Our Case Number: ABP-317742-23

Re: BusConnects Bray to City Centre Core Bus Corridor Scheme
Bray to Dublin City Centre.

**Bray to City Centre BusConnects Scheme
(ABP Reg. Ref. HA27.317742)**

Client:	Sir Marc Cochrane
Project Title:	BusConnects Bray to City Centre Route
Document Title:	BusConnects Submission – Woodbrook Estate
Document/Job	JSA 19089 Ref 10102023 DV4

Figure 3.2: Extract from General Arrangement Sheet 50 (Source: NTA, 2023) with redline illustrating Woodbrook Estate.

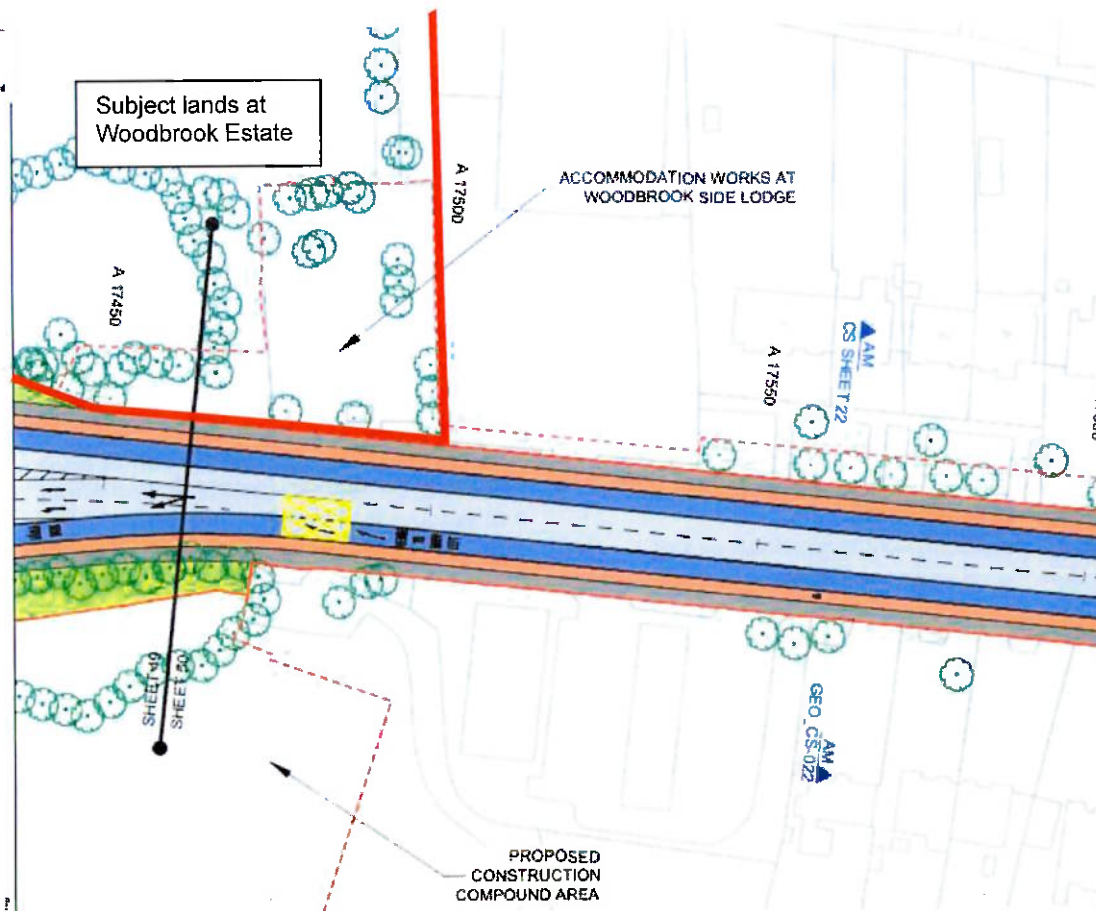
- 3.2. Extracts of the 'General Arrangement Drawings' Sheets 49-50 (Figure 1 and 2 below) set out high level details of the route proximate to the Woodbrook Estate.

3.4. The application documentation notes the impact on Woodbrook Estate through the demolition of Woodbrook Side Lodge, a protected structure, and that a new lodge is to be rebuilt. The boundary wall, and pedestrian and vehicle gated access points to Side Lodge are proposed to be rebuilt utilising existing materials where possible.

- 3.5. Enclosed landscaping drawings details sets out trees proposed to be removed along the boundary with the Woodbrook Estate primarily on the eastern side of the Dublin Road. Annotation on the drawing states that existing wall, trees and vegetation up to 4m from the wall to be removed. The wall is to be set back and re-built.

- 3.6. The alignment through this section entails significant tree loss along the frontage with Woodbrook Estate back. Replacement native planting is proposed to re-establish the vegetation belt along this side however the nature and extent of this planting is not clear. The existing wall is to be demolished and set back proposed wall reinstatement north of the M11 diverge junction will be detailed to match the stone material seen elsewhere along this section.

Figure 3.4: Extract from Appendix D Arboricultural Impact Assessment (Source: NTA, 2023) with redline illustrating Woodbrook Estate property

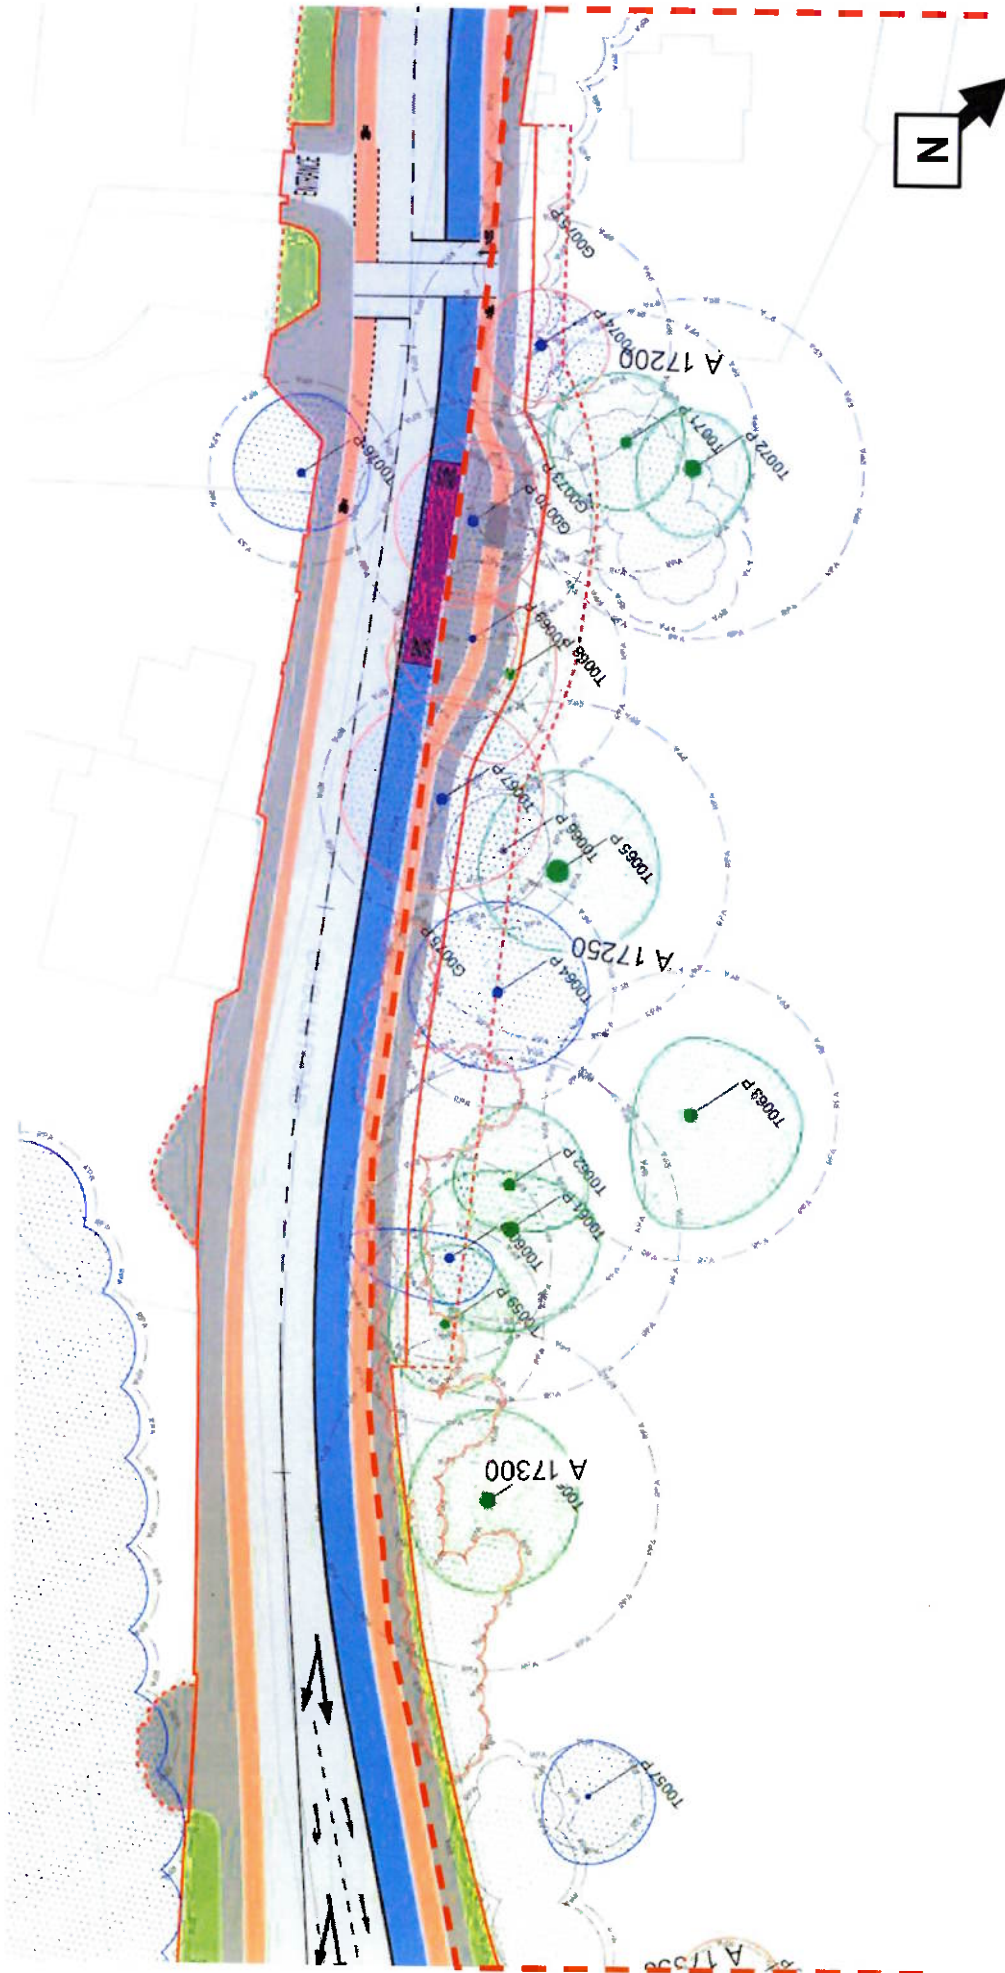
- 3.7. The drawing also notes: *'Stone setts and wide granite kerbs to enhance historic gated entrance into Woodbrook estate.'*
- 3.8. Figures 3.3 and 3.4 below illustrate the extent of landscaping proposals and the consequent loss of trees proposed.

- 3.9. The proposal states that the historic gated entrance into the Woodbrook Estate remains unaffected by any carriageway widening. The landscape drawing notes: *'Stone setts and wide granite kerbs to enhance historic gated entrance into Woodbrook estate' are proposed which are considered a positive intervention.'*

Figure 5.4: Extract from '20.-Woodbrook-Side-Lodge-General-Arrangement-1' (Source: NTA, 2023).

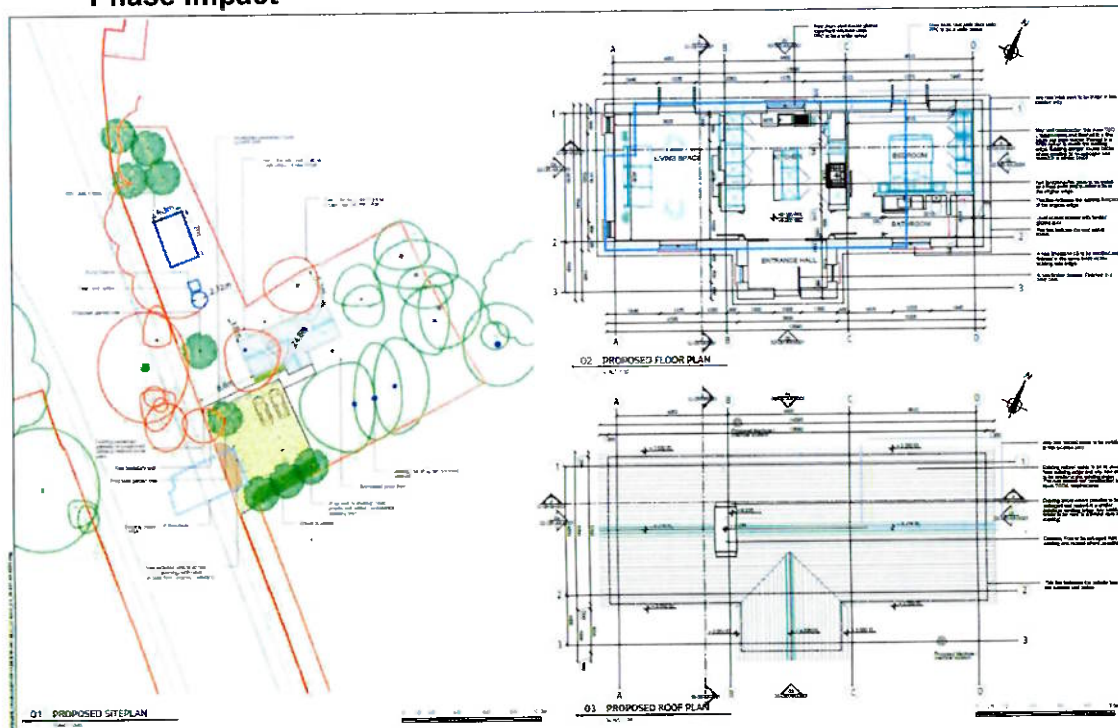
- 5.11. The proposal notes that the historic gated entrance into the Woodbrook Estate remains unaffected by any carriageway widening. The landscape drawing notes: *'Stone setts and wide granite kerbs to enhance historic gated entrance into Woodbrook estate'* are proposed which are considered a positive intervention.

- 5.14. We note the provisions of Section 57(10)(b) of the Planning and Development Act (as amended) which states:
- "A planning authority, or the Board on appeal, shall not grant permission for the demolition of a protected structure or proposed protected structure, save in exceptional circumstances."*

- 8.9. We request that ABP request that the Applicant provide revised drawings of the proposal as detailed in this submission, and in particular, an alternative layout which significantly reduces the impact on the historic and sensitive landscape of the Woodbrook area, retaining the Woodbrook Side Lodge, a protected structure.

Fig. 2 – Northern section of Estate frontage

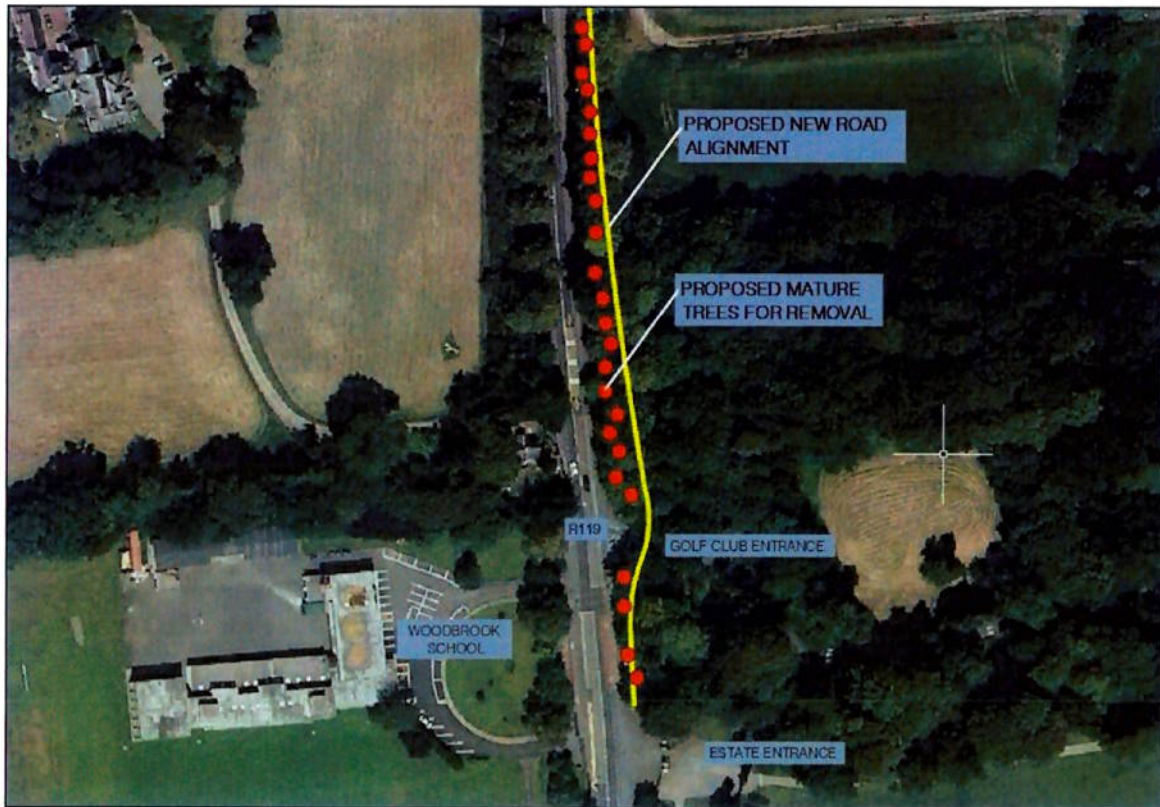
The northern section of the estate frontage includes a narrow group of trees with open fields to the rear and a section with dense mature woodland. The trees are mainly mature Chestnut (*Aesculus hippocastaneum*) up to 20M in height and with several mature Beech (*Fagus sylvatica*) also up to 20M in height. All the trees are within 5M of the boundary wall. There is also of a stone lined feature which runs at right angles to the boundary wall and there is a height differential between one side and the other.

The condition of the trees while mature is generally good with few fallen trees and branches partially due to the fact that the area has been undisturbed for some time. There is also little evidence of disease present in the trees. The understory is composed of regenerating seedlings and groups of Cherry Laurel (*Prunus laurocerasus*) with Ivy (*Hedera helix*) and Wild Garlic (*Allium ursinum*)

The removal of the tree line adjoining the field would leave a significant gap in the roadside tree line which would greatly alter the environment and visual amenity of the roadside planting. The removal of trees at the western edge of the woodland would put the remaining adjoining trees at risk of wind damage.

Fig. 3 – Entrance gates & gate lodge

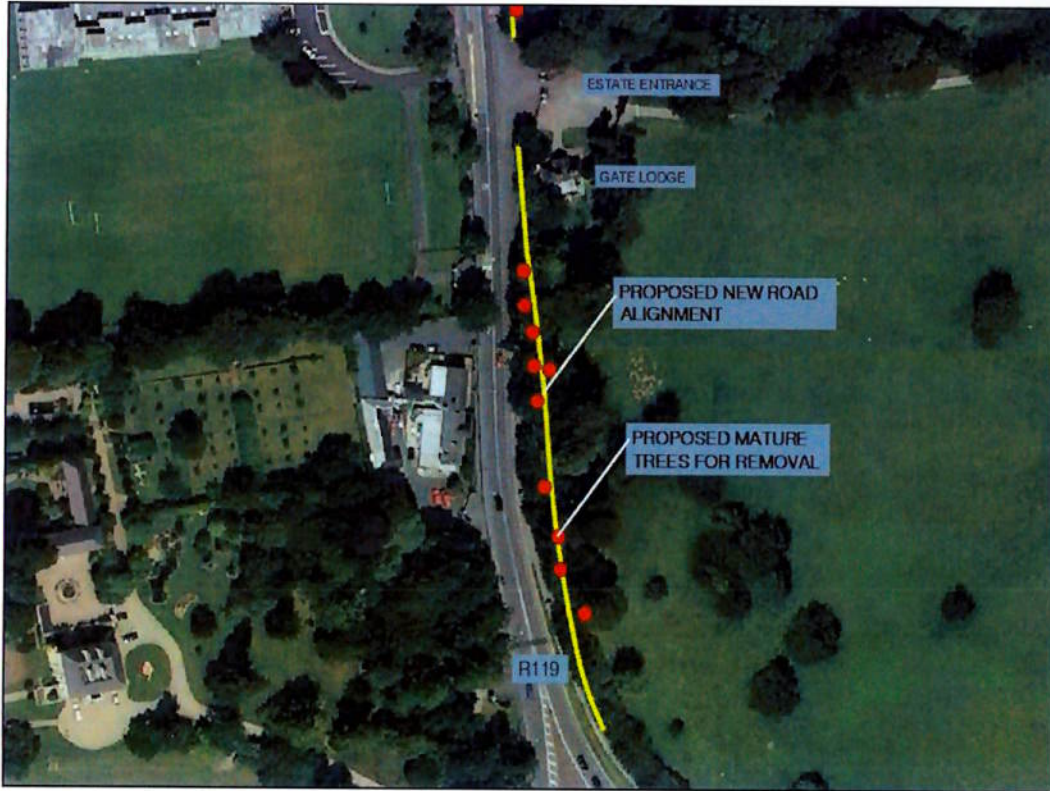
The middle section of the Estate frontage includes the listed entrance gates and listed gate lodge. While the widening proposals will retain the entrance gates and gate lodge the trees on either side of the gateway would be removed which would create a significant visual impact on the setting of the gates and gate lodge.

The proposed works in this area would remove the majority of the mature trees exposing the estate to adjoining properties and impacting on views from the house and grounds.

Fig. 4 – Roundabout & southern section

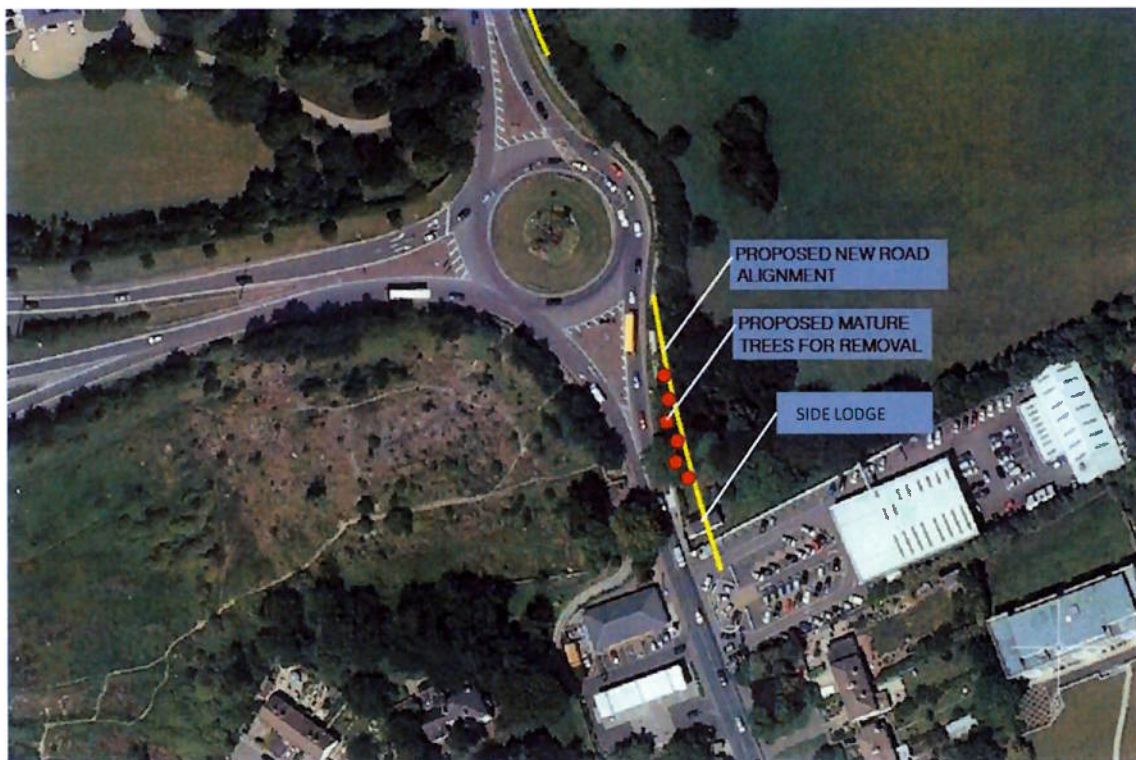
grounds from traffic entering and existing the M11. The BusConnects proposals will result in the removal of a significant number of mature woodland trees from the corner of the site. The creation of manageable slopes would also result in more trees being removed.

Figure 2 – Annotated Extract NTA GA Drawing #48 of 54

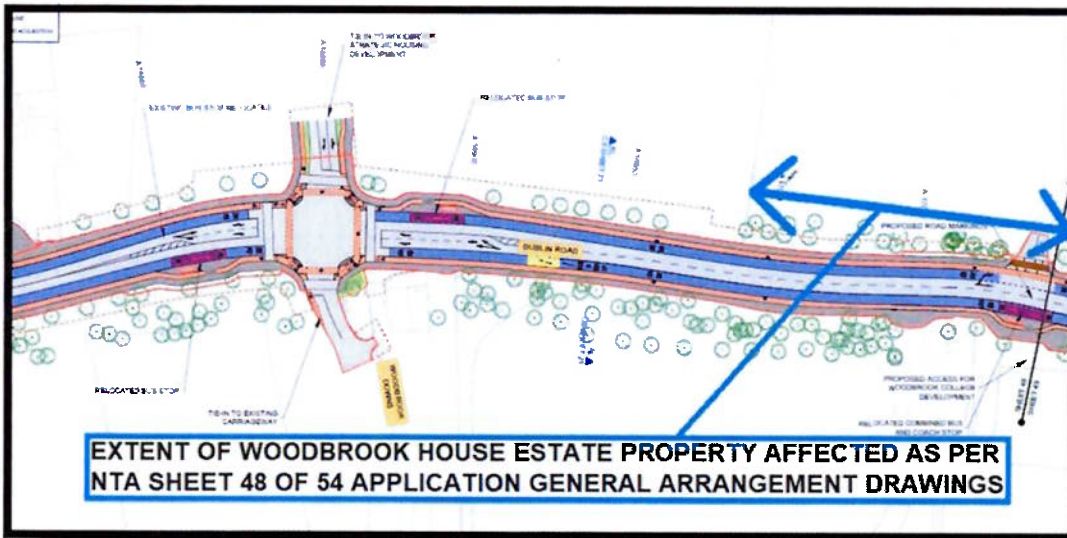
We use annotated extracts from the NTA General Arrangement Drawings (Sheet #48 and #49) below to identify the clients lands affected by the Bus Connects Plans, below as **Figure 2** and **Figure 3**.

As part of our previous work, we reviewed the original Emerging Preferred Route proposal and considered viable alternatives for this section of the proposed bus corridor which would not entail such extensive land-take of the property, and importantly which would permit the majority of the existing mature trees to be retained.

As previously proposed, we believe that the appropriate and far less damaging / contentious option for the Bray / City Centre section of Core Corridor 13 here would be to utilise a shared cycle & bus lane on both sides at this area, **similar to other sections of the Planned route e.g., in Donnybrook**. Unlike the offline cycle lane option proposed at Shankill, which is less direct and longer and therefore less attractive to cyclists, this provides a direct route to cyclists while reducing the impact on Woodbrook Estate.
